Response to Reviewer 2 Comments

Title: *Orphaned Oil & Gas Well Methane Emission Rates Quantified with Gaussian Plume Inversions of Ambient Observations*

Manuscript ID: *egusphere-2025-344*

Figure 1: Example of raw concentration data sampled at 1 Hz while the well was being vented demonstrating duration of periods of elevated CH₄.

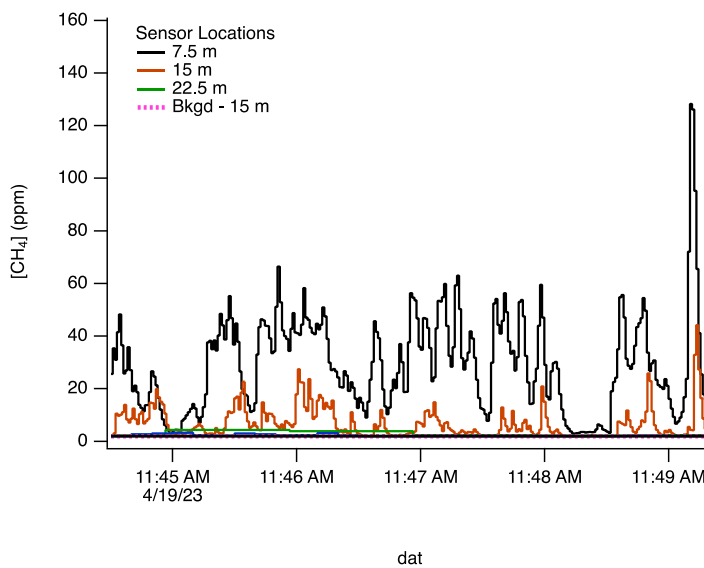
- Downwind distances – can authors elaborate on the details related to the design of the experiment, including (i) a discussion on the reason for selecting 7.5m, 15m, 22.5m, and 47m and selected downwind distances for monitors, (ii) employing measurement units from two different manufacturers, which may introduce a level of uncertainty, and (iii) the reason for deploying Aeris Pico at a height of 0.8m.

- i) Sensor locations were chosen as a compromise between being far enough away from the methane source where the plume was broad enough for robust detection, but near enough to the source that dispersion did not diminish the signal. Figure 6 of our manuscript shows the broadening of plumes with respect to distance downwind.

We observed strong winds that varied little in direction and peaks in concentration typically lasted less than 1 minute (see figure with raw data below). There is not a simple metric for plume duration and concentrations are observed to fluctuate during the “in plume” measurement periods. Dispersion is due to several processes, including changing wind directions, turbulent mixing (changes in wind speed), and (minor) diffusion. These operate on different time/space scales. At 1 Hz sampling rate this meant the plume was only observed for <60 measurements with a smaller number at peak concentrations. In our analysis we averaged data over a 1-minute interval (section 3.1.1) which smooths out high frequency wind fluctuations.

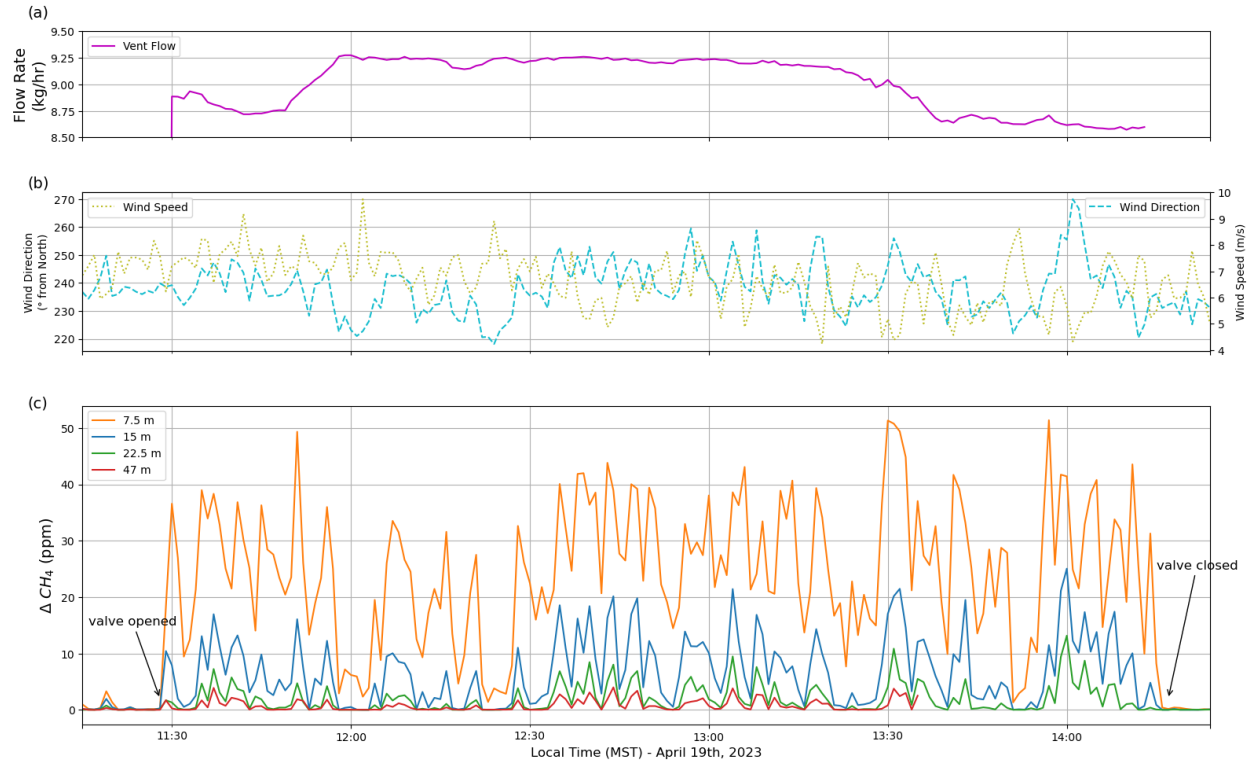
- For Figure 10, can you please include timeseries of wind speed and wind direction, as well?

Yes, we agree this is valuable and have updated Figure 4(b) as well to include these.

Figure 3: Comparison of model results to assess impact of accounting for different uncertainties and processes: a) uncertainty in excess CH₄, b) impacts of assuming plume rise, c) uncertainty in excess CH₄ when assuming ground reflection, and d) impact of ground reflection.

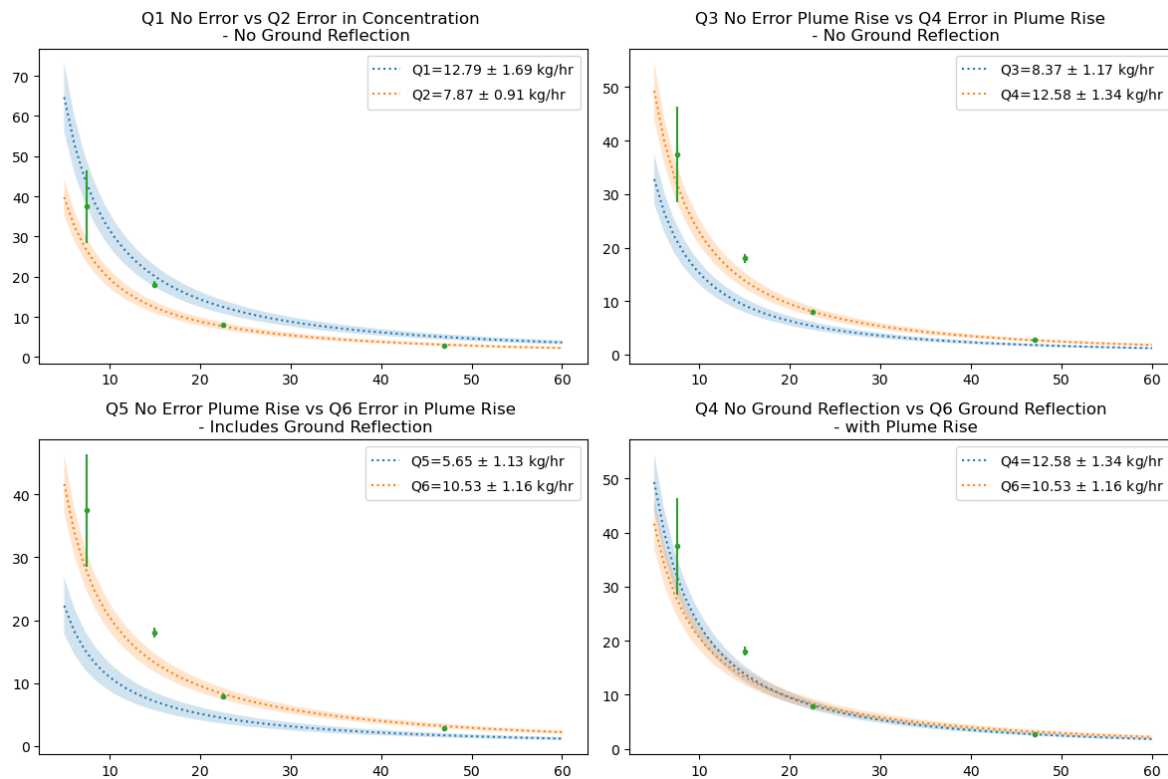
- Line 325: Please elaborate on the following statement “Other iterations of our empirically constrained dispersion model, where plume rise or ground reflection are excluded, result in estimates from 5.6 - 12.8 kg CH₄ h⁻¹...”

We understand this was a bit confusing. This wording was meant to address the many iterations of the plume model (Equation 1) run by changing different parameters to understand the effects of plume rise, ground reflectance, plume spread, stability class, and more on the accuracy of the estimated methane flux (shown in Table 2 for one sensor, section 3.2.1 for stability class). We have updated the information in the manuscript.

Specifically, Gaussian plume models can be adapted to incorporate different processes. In this manuscript we assume that a plume is transported downwind with a horizontal and vertical velocity measured by our sonic anemometers. Additionally, we assume that the plume cannot travel into the ground and account for this boundary condition by assuming the Gaussian shape is “reflected” from the ground surface (Section 18.9.1.1 Seinfeld & Pandis, 2016).

We ran several iterations of our Gaussian Plume model accounting for errors in the different parameters of the Gaussian plume equation (as shown in the figure below). We account for error based on concentration values, plume rise, and ground reflection. This is where we derive these estimates of 5.6 – 12.8 kg CH₄ h⁻¹.

We have added the following text to clarify this statement:

“An error analysis was ran accounting for propagating errors in the model parameters of plume rise, ground reflectance, and the measured concentration of our empirically constrained dispersion Gaussian plume model. This error analysis resulted in estimates from 5.6 - 12.8 kg CH₄ h⁻¹ that is within -62% to +42% of the directly measured leak of 9.0 ± 0.25 kg CH₄ h⁻¹.”
